Subject: Possession Only License for the University of Arizona Research Reactor,
Facility License No. R-52, Docket No. 50-113

This letter requests a 'possession only' revision to our current operating license and submits revised Technical Specifications. Please delete the words "use, and operate" from the following part of our license:

TECHNICAL SPECIFICATIONS
FOR THE
UNIVERSITY OF ARIZONA
TRIGA RESEARCH REACTOR
FACILITY LICENSE R-52
Amendment 19

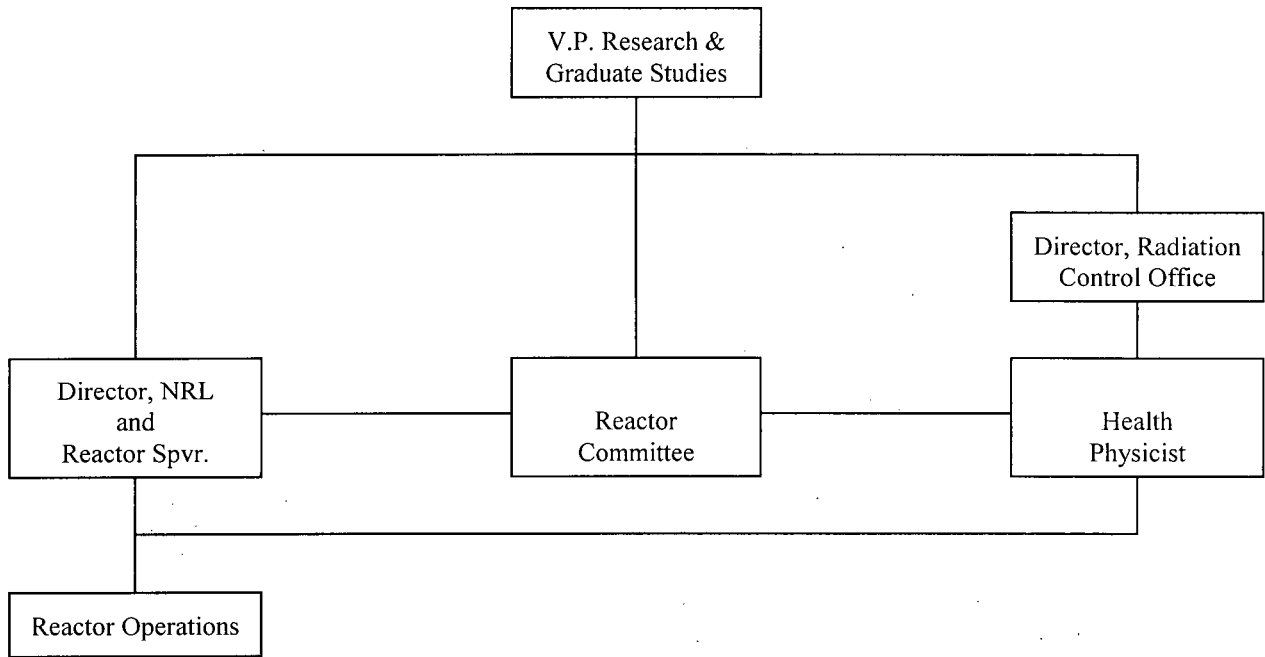
The above organizational chart from our Decommissioning Plan replaces the organizational chart below when decommissioning activities commence. Until then, the following chart remains applicable.

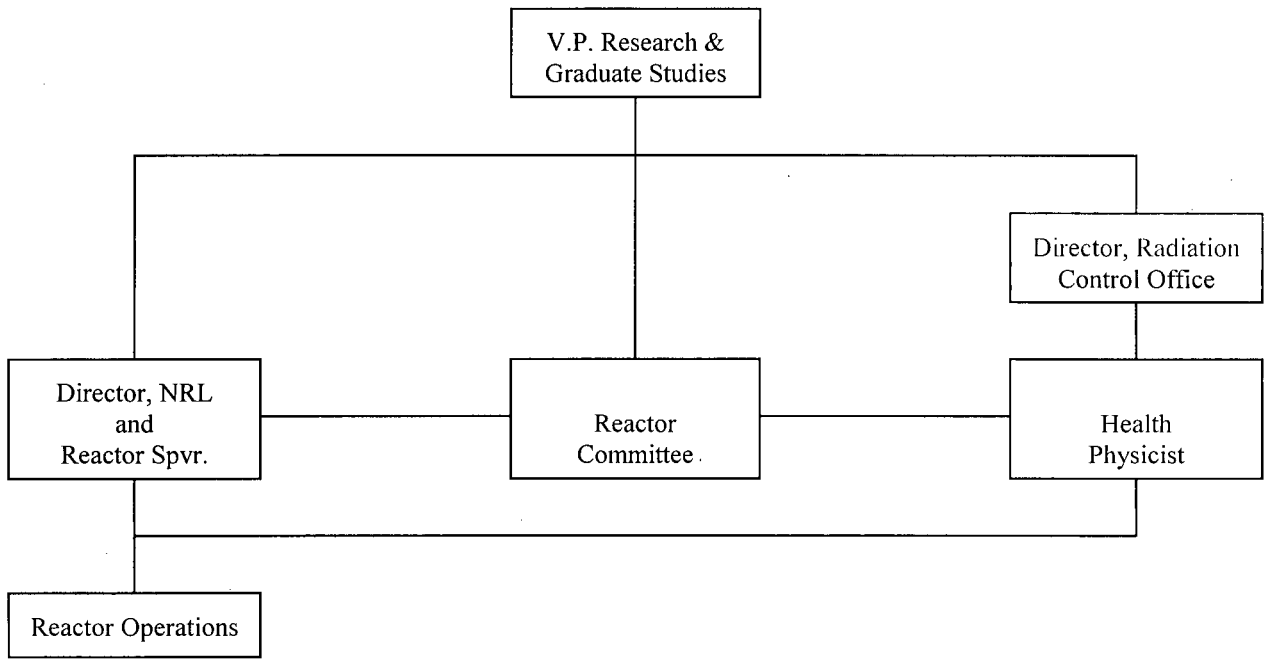
The ADMINISTRATIVE CONTROLS ORGANIZATION section remains unaffected when our operations cease, but changes become applicable when we begin decommissioning activities.

The above organizational chart from our Decommissioning Plan replaces the organizational chart below when decommissioning activities commence. Until then, the following chart remains applicable.
